STATE OF NORTH CAROLINA  
DEPARTMENT OF TRANSPORTATION

March 13, 2008

Subject: Request for Section 401 and Section 404 Individual Permit Modification and Permit Extension for Widening of US 15-501 from north of SR 2294 (Mt. Moriah Road) to south of SR 1116 (Garrett Road) in Durham County. Federal Project No. NHF-15 (8), State Project No. 8.1352301, Division 5, WBS Element No. 35012.1.1, TIP No. U-4012.

PROJECT REFERENCE NO. U-4012	SHEET NO. 3
RW SHEET NO.	
ROADWAY DESIGN ENGINEER	HYDRAULICS ENGINEER
Permit Drawing Sheet 3 of 15	
PRELIMINARY PLANS DO NOT USE FOR CONSTRUCTION	
Revised 1/23/08

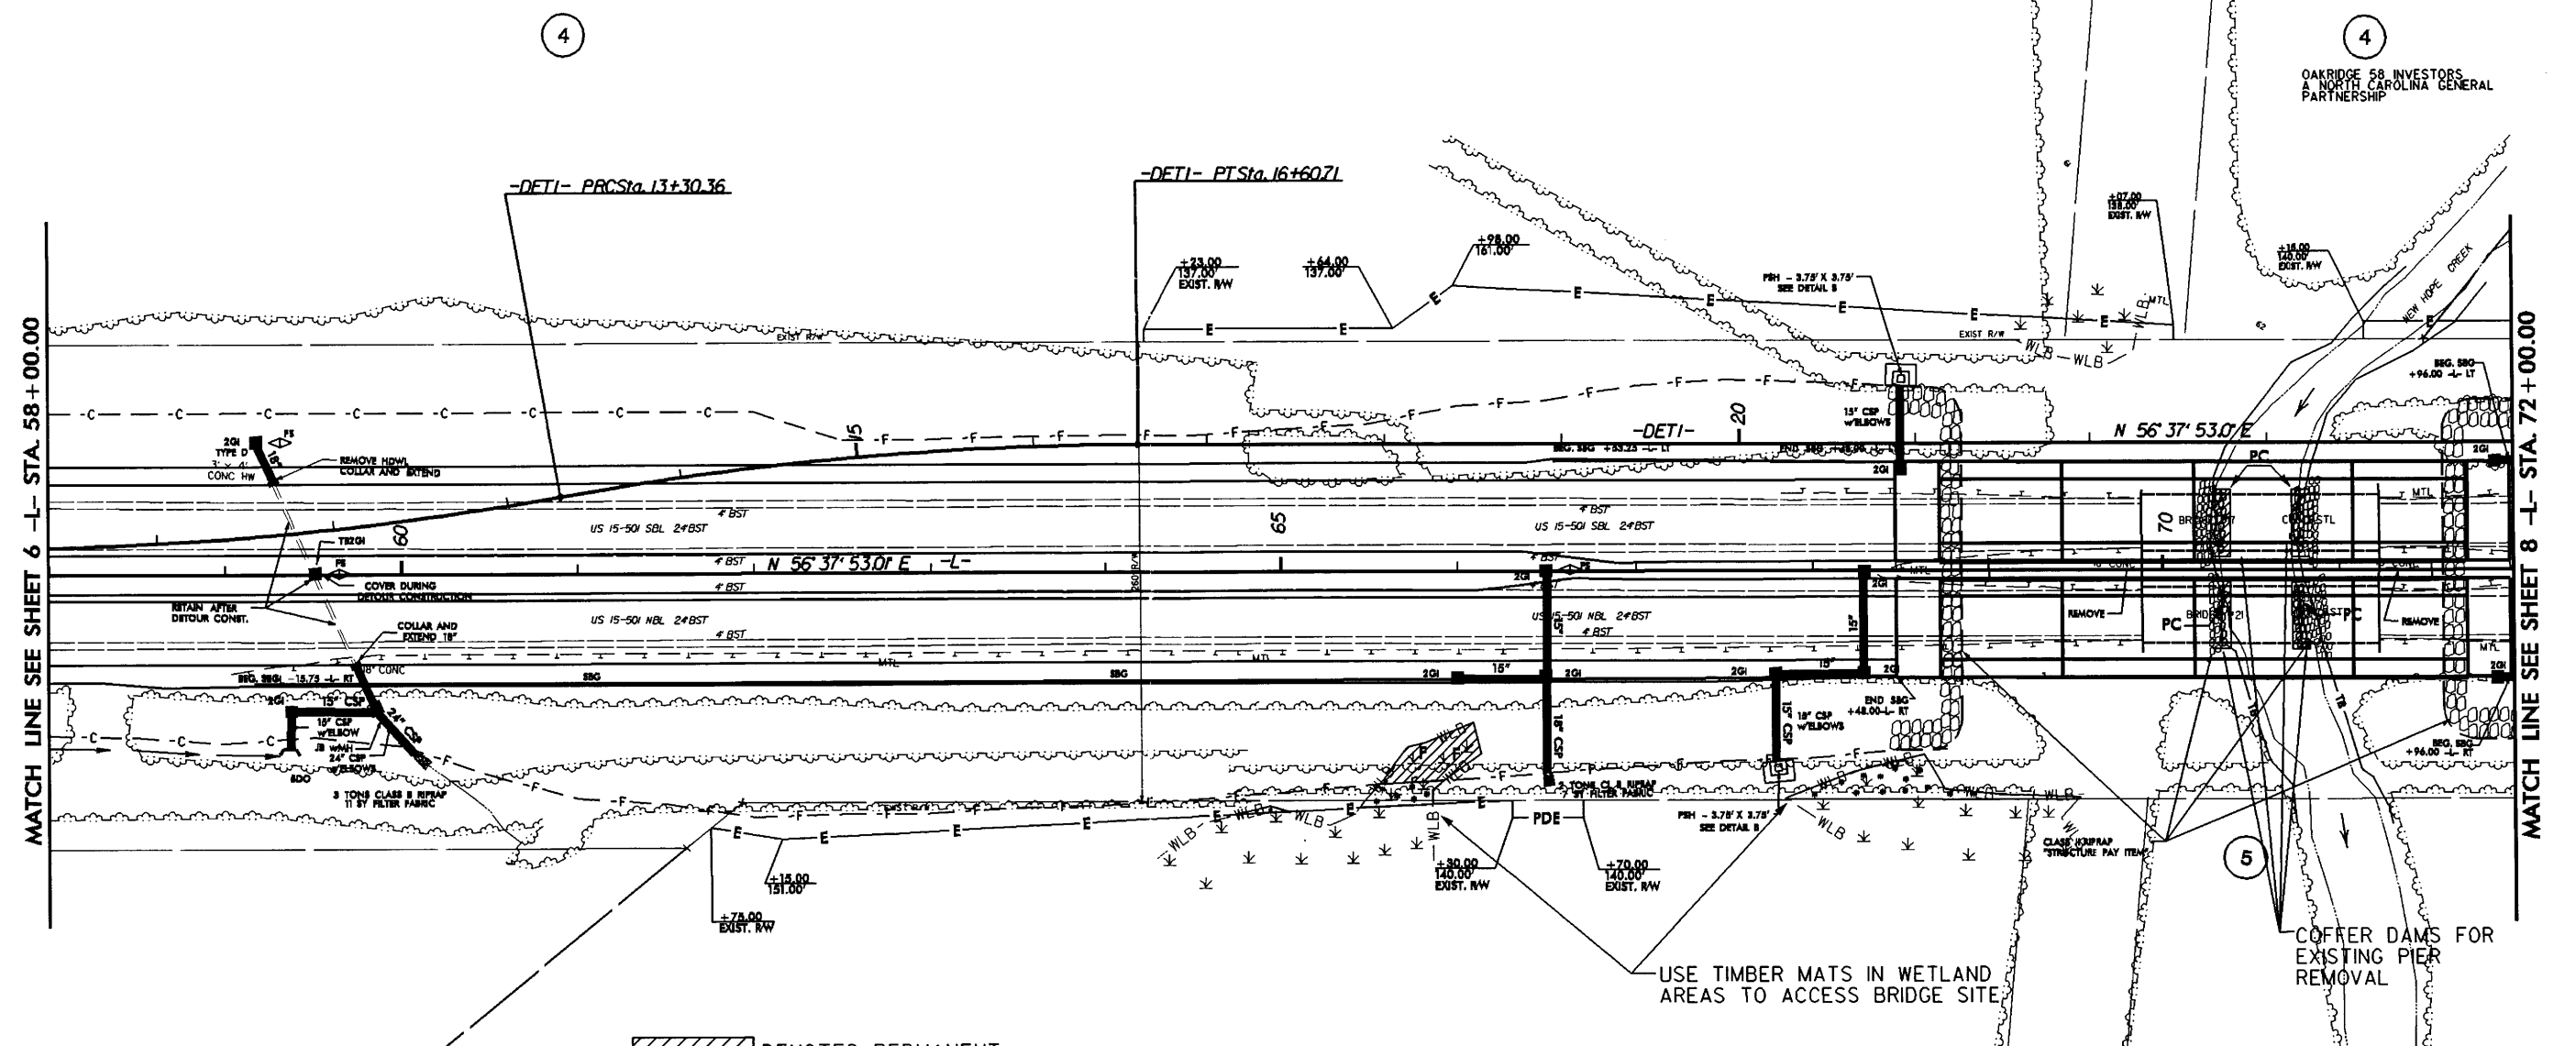
The described changes were to be depicted on the plan and profile views. This information is not depicted on any permit drawings submitted to the regulatory agencies as part of the permit application dated December 13, 2004. The attached revised permit drawings 3, 7, 11 and 14 of 15 indicate the permanent installation of Class II rip rap below normal water surface on New Hope Creek at 70+35 and 70+75 -L- to stabilize the stream banks after removal of existing piers.

Jurisdictional Changes: The installation of Class II rip rap below normal water surface on New Hope Creek at 70+35 and 70+75 -L- will result in an additional 72 linear feet of permanent stream impact due to bank stabilization. The revised plan sheet 7 is also included.

**NOTE: PERMANENT CHANNEL IMPACTS DUE TO RIP RAP STABILIZATION OF STREAM BANKS BELOW NORMAL WATER SURFACE DUE TO REMOVAL OF EXISTING PIERS.**

PROJECT REFERENCE NO. U-4012	SHEET NO. 7
RW SHEET NO.	
ROADWAY DESIGN ENGINEER	HYDRAULICS ENGINEER
Permit Drawing	
Sheet 7 of 15	
PRELIMINARY PLANS DO NOT USE FOR CONSTRUCTION	
Revised 1/26/08

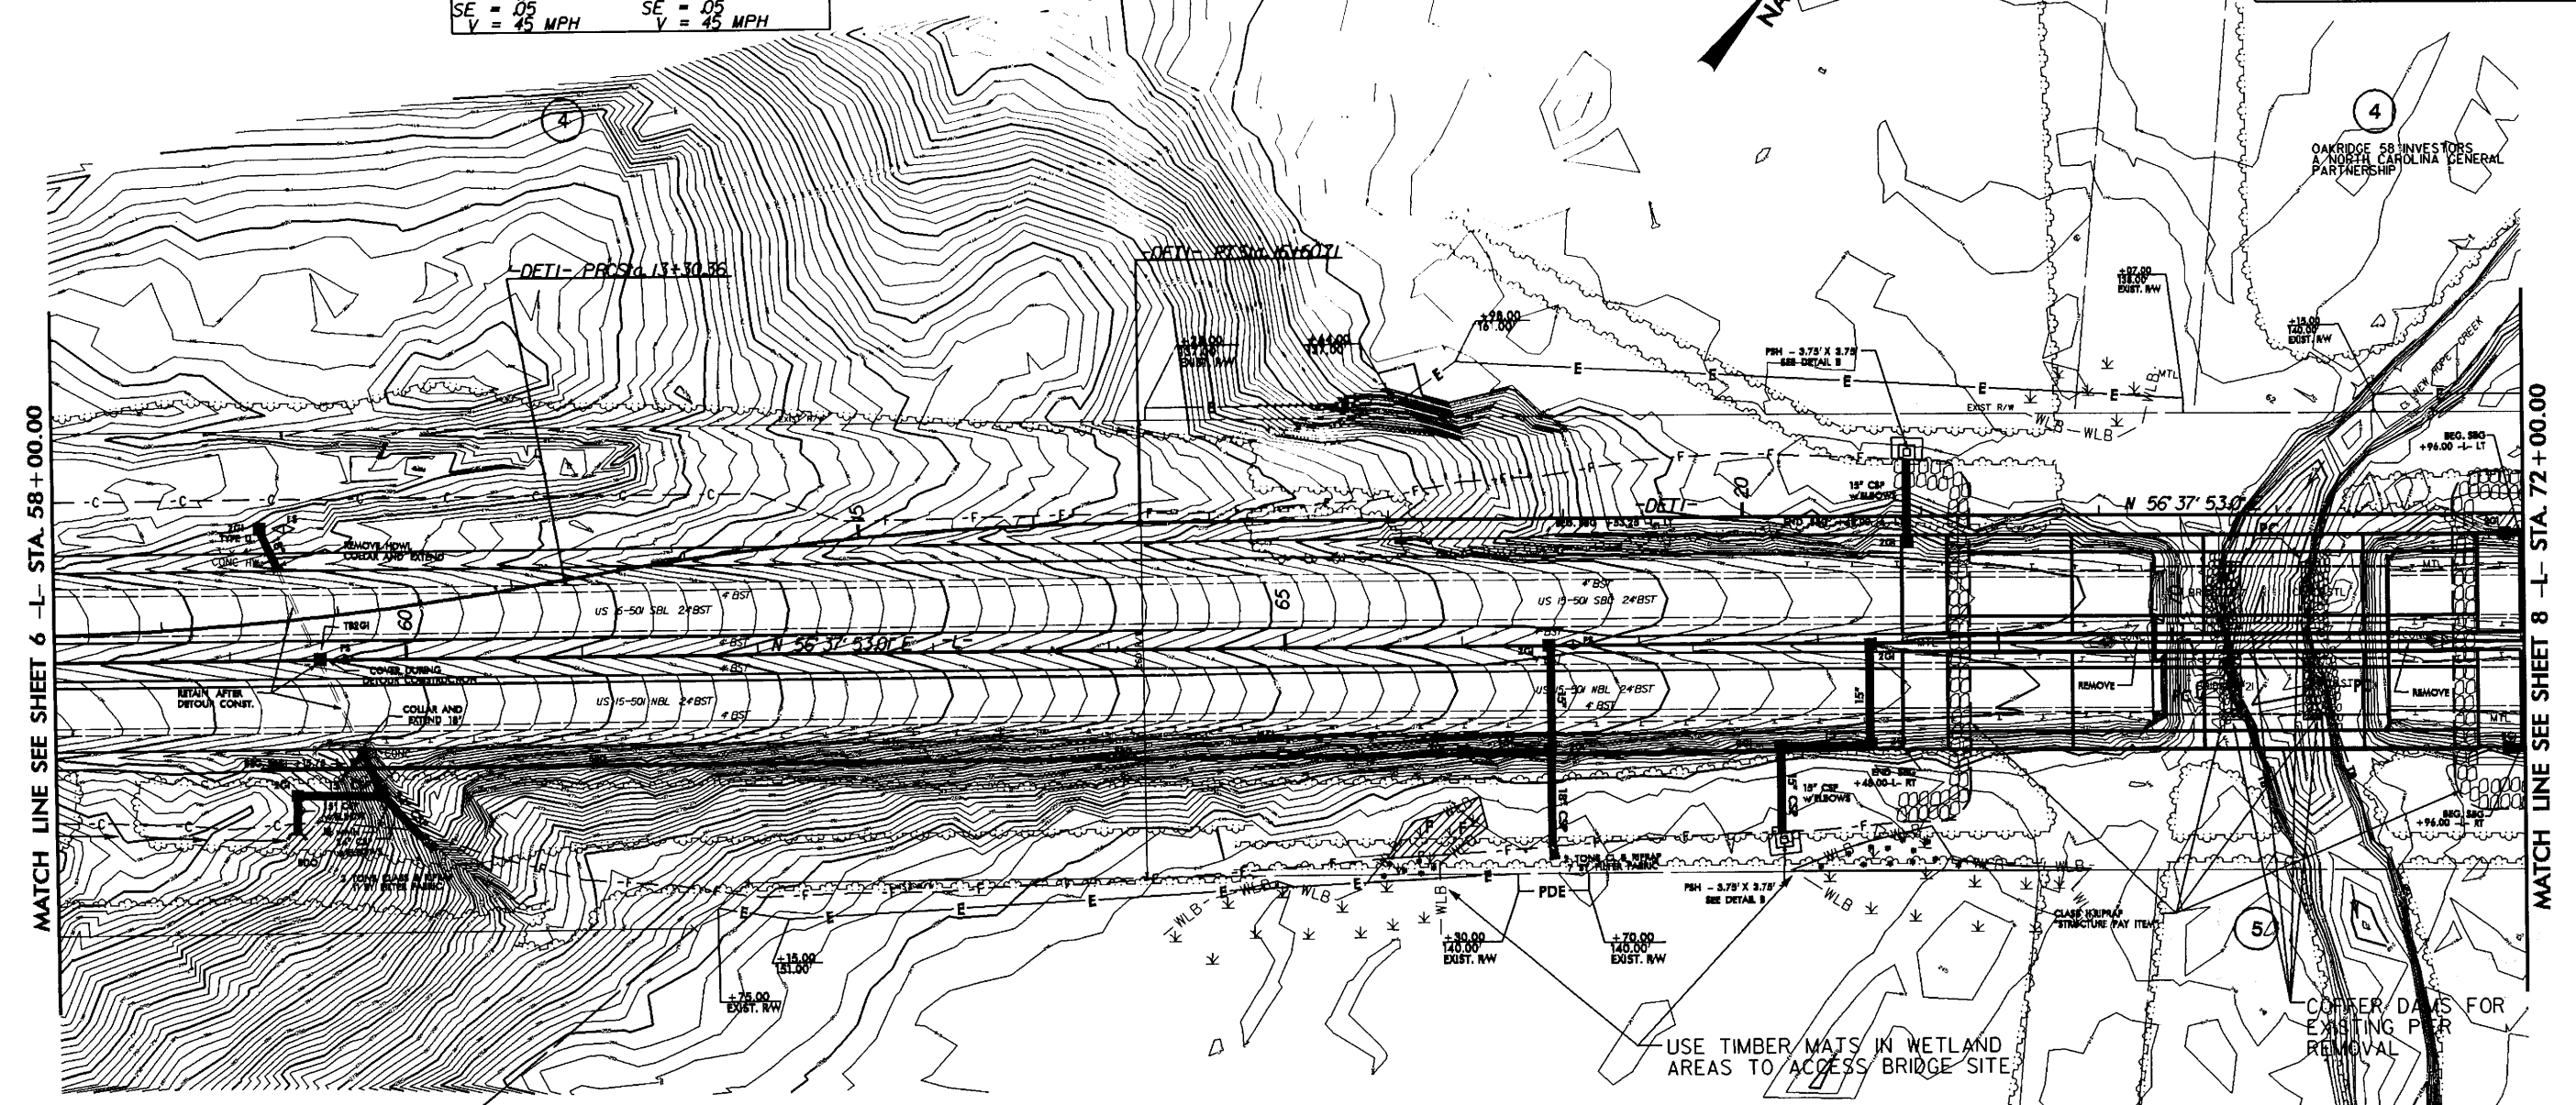
NOTE: PERMANENT CHANNEL IMPACTS DUE TO RIP RAP STABILIZATION OF STREAM BANKS BELOW NORMAL WATER SURFACE DUE TO REMOVAL OF EXISTING PIERS.

5/28/99  
 Const. Rev. - Additional Rip Rap added around the bridge piers of the existing US 15-501 bridges to match the Structure Design plans. BCK 1-22-08  
 23-JAN-2008 13:29  
 1-DP-03 \04081-01-1-HY221538  
 K:\04081-01-1-HY221538

-L- STA 78+85 TO 81+50 RT

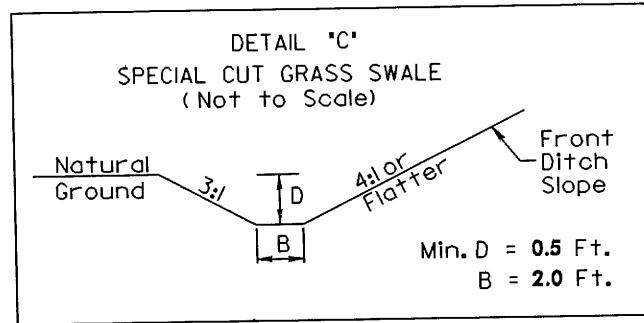
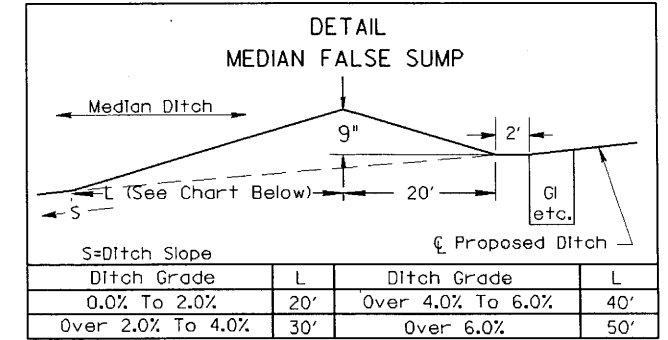
In the original permit drawings submitted, permit drawing 4 of 15 indicates that Special Cut Grass Swale (Detail C) is from 78+85 to 81+00 Rt. Plan Sheets 2-F and 8 indicate that Special Cut Grass Swale (Detail C) is from 78+85 to 81+50 Rt. The NCDOT Hydraulics Unit has indicated that the Special Cut Grass Swale (Detail C) should be constructed from 78+85 to 81+50 Rt. See the attached revised plan sheets 2-F and 8. This construction revision will not result in additional impacts to streams, wetlands or surface waters.

-L- STA 79+00 TO 81+50 LT

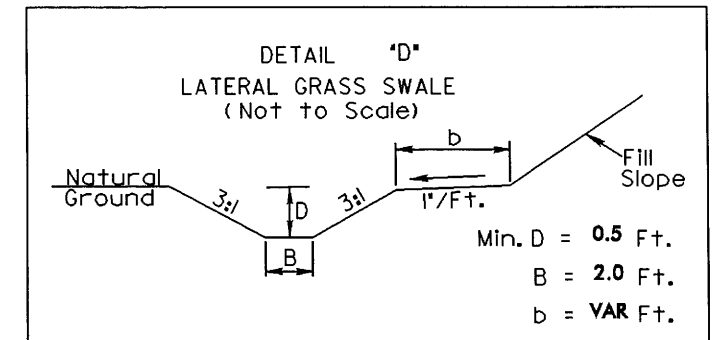
In the original permit drawings submitted, permit drawing 4 indicates that Lateral Grass Swale (Detail D) is from 79+00 to 81+00 Lt. Plan Sheets 2-F and 8 indicate that Lateral Grass Swale (Detail D) is from 79+00 to 81+50 Lt. The NCDOT Hydraulics Unit has indicated that the Lateral Grass Swale (Detail D) should be constructed from 79+00 to 81+50 Lt. See the attached revised plan sheets 2-F and 8. This construction revision will not result in additional impacts to streams, wetlands or surface waters.

PROJECT REFERENCE NO.	SHEET NO.
U-4012	7
R/W SHEET NO.	7
ROADWAY DESIGN ENGINEER	HYDRAULICS ENGINEER

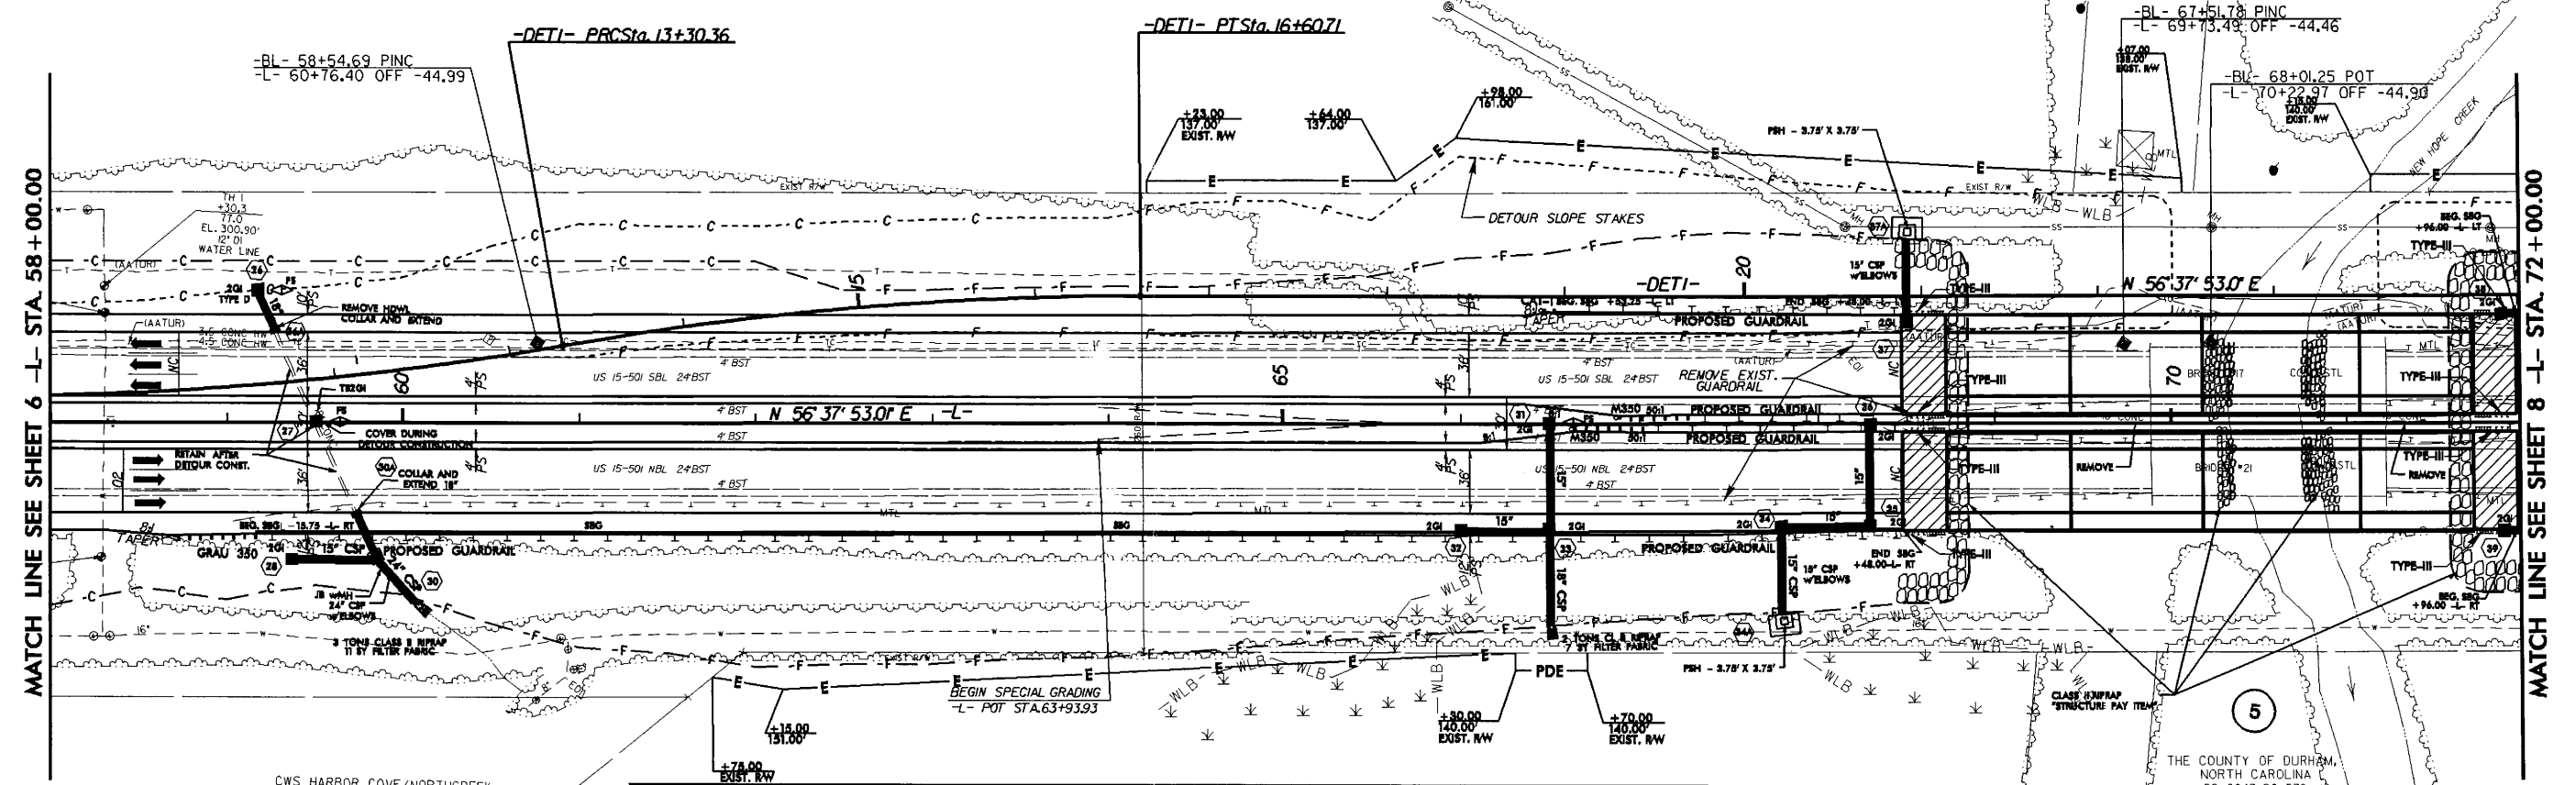
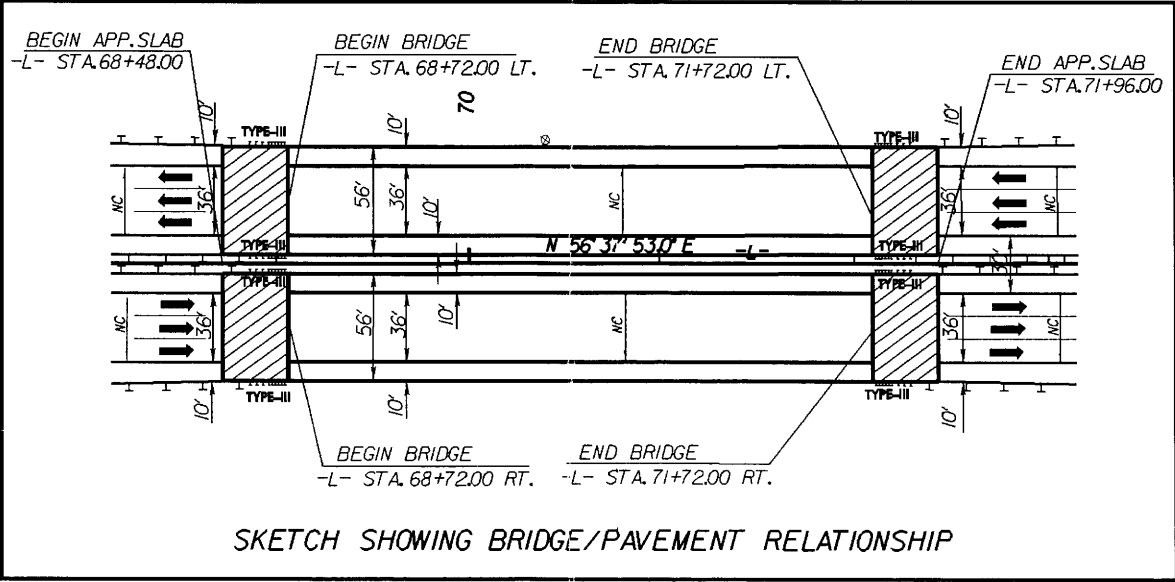
Const. Rev. - Additional Rip Rap added around the bridge piers of the existing US 15-501 bridges to match the Structure Design plans. BCK 1-22-08
